**FINDINGS AND RECOMMENDATION  
OFFICE OF PLANNING AND ZONING  
ANNE ARUNDEL COUNTY, MARYLAND**

**CASE NUMBER:** 2023-0198-V

**REQUEST**

The applicants seek variances to allow dwelling additions and renovations (installation of a new septic tank and drywell; expansion of the existing attached garage; relocation of the front entry & approach walkway; construction of an upper-story deck on the water side; and replacement of the existing retaining wall) with less setbacks and buffer than required and with disturbance to slopes of 15% or greater at 1330 Kinloch Circle in Arnold.

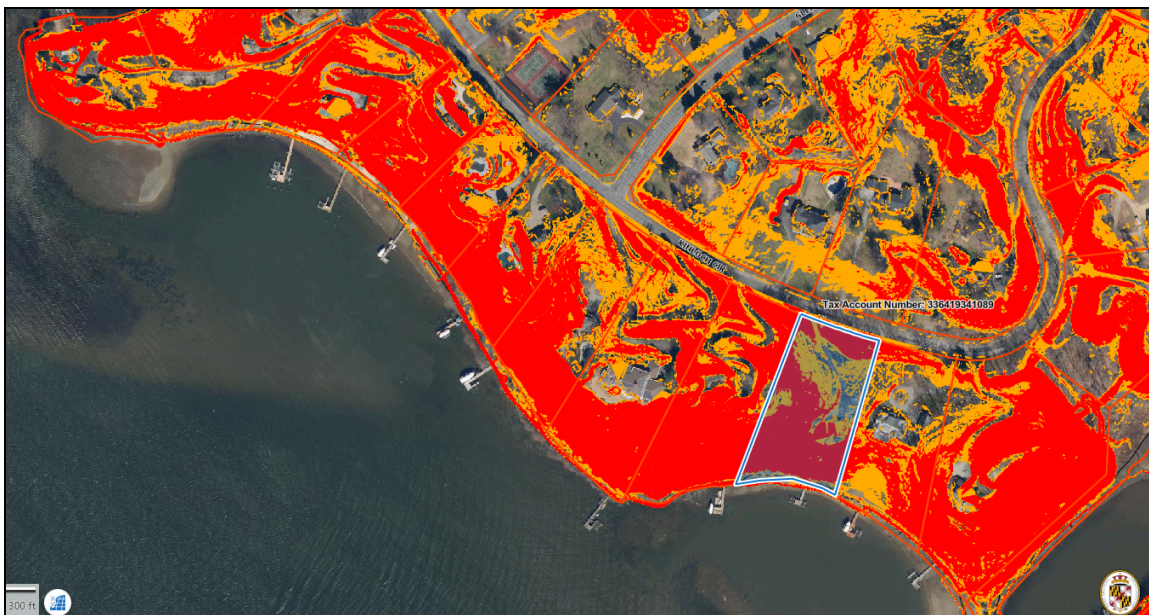
Steep slopes along the shore of this length of the Severn River and the expanded buffer are shared by neighboring properties and are not unique to the site, and therefore the prohibitions against their disturbance do not *uniquely* affect property owners or the subject property. Steep slopes are shown in red (25% and greater slopes) and yellow (15%-24.99%) on the below image; the subject property is shown shaded slightly blue.
